V2500 D5 SERIES PROPULSION SYSTEM NON-MODIFICATION SERVICE BULLETIN

This document transmits Revision 2 to Service Bulletin EV2500-72-0499

Remove	Incorporate	Reason for change
Pages 1 to 6 of the Service Bulletin	Pages 1 to 18 of the Service Bulletin	To introduce acceptance and fly-on limits for the borescope inspection of the HP compressor stage 6 and 7 stator vanes and the HP compressor stages 6 to 8 rotor blades.

ENGINE – HP COMPRESSOR – BORESCOPE INSPECTION OF STAGES 6 TO 8 ROTOR BLADES AND
STAGES 6 TO 7 STATOR VANES – NON-MODIFICATION SERVICE BULLETIN

HPC stage 6 stator vane; loss of material with a jagged T/E profile
Figure 8

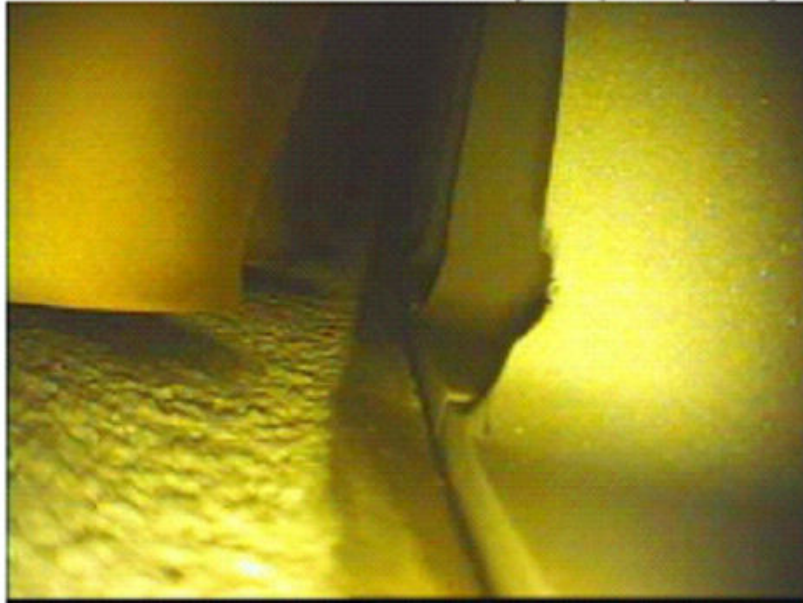
(c) Loss of material from trailing edge with or without a jagged trailing edge profile (Refer to Figures 7 and 8)

(c) Loss of material from trailing edge with or without a jagged T/E profile (Refer to Figures 7 and 8)

A	Not more than 0.006 in. (0,15 mm) in axial depth	Repeat borescope inspection within 500 cycles.
B	More than A, but not more than 0.016 in. (0,4 mm) in axial depth	Repeat borescope inspection within 250 cycles.
C	More than B, but not more than 0.035 in. (0,9 mm) in axial depth	Repeat borescope inspection within 125 cycles.
D	More than C, but not more than 0.079 in. (2 mm) in axial depth	Reject the engine within 10 cycles.
E	More than D	Reject.

A	Not more than 0.006 in. (0,15 mm) in axial depth	Repeat borescope inspection within 500 cycles.
B	More than A, but not more than 0.016 in. (0,4 mm) in axial depth	Repeat borescope inspection within 250 cycles.
C	More than B, but not more than 0.035 in. (0,9 mm) in axial depth	Repeat borescope inspection within 125 cycles.
D	More than C, but not more than 0.079 in. (2 mm) in axial depth	Reject the engine within 10 cycles.
E	More than D	Reject.

HPC stage 6 rotor blade without blade tip erosion
Figure 10

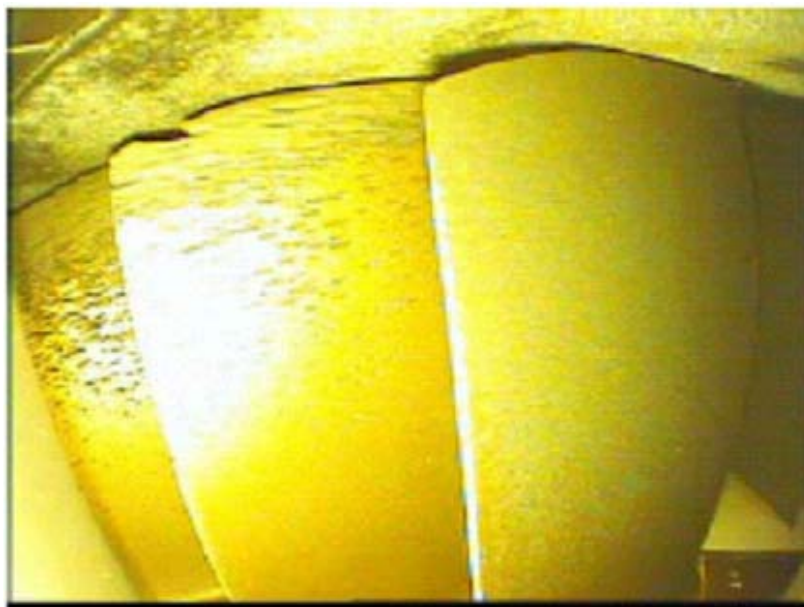
R (a) Repeat borescope inspection within 500 cycles if the chordal extent of the erosion is less than 25 percent of the remaining chord (Refer to Figures 10 and 11).

(a) Repeat borescope inspection within 500 cycles if the chordal extent of the erosion is less than 25 percent of the remaining chord (Refer to Figures 10 and 11).

(a) Repeat borescope inspection within 500 cycles if the chordal extent of the erosion is less than 25 percent of the remaining chord (Refer to Figures 10 and 11).

Figure 12

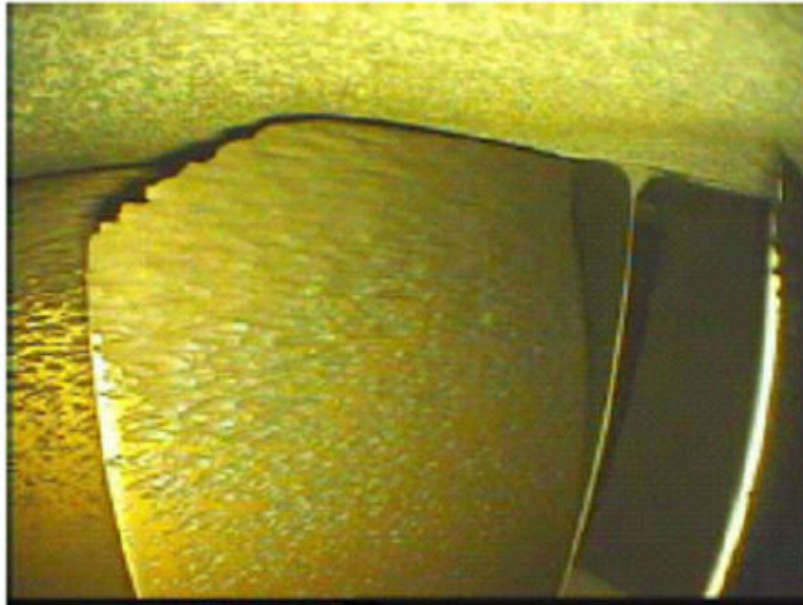
R (b) Repeat borescope inspection within 125 cycles if the chordal extent of the erosion is greater than 25 percent but less than 50 percent of the remaining chord (Refer to Figure 12).

(b) Repeat borescope inspection within 125 cycles if the chordal extent of the erosion is greater than 25 percent but less than 50 percent of the remaining chord (Refer to Figure 12).

(b) Repeat borescope inspection within 125 cycles if the chordal extent of the erosion is greater than 25 percent but less than 50 percent of the remaining chord (Refer to Figure 12).
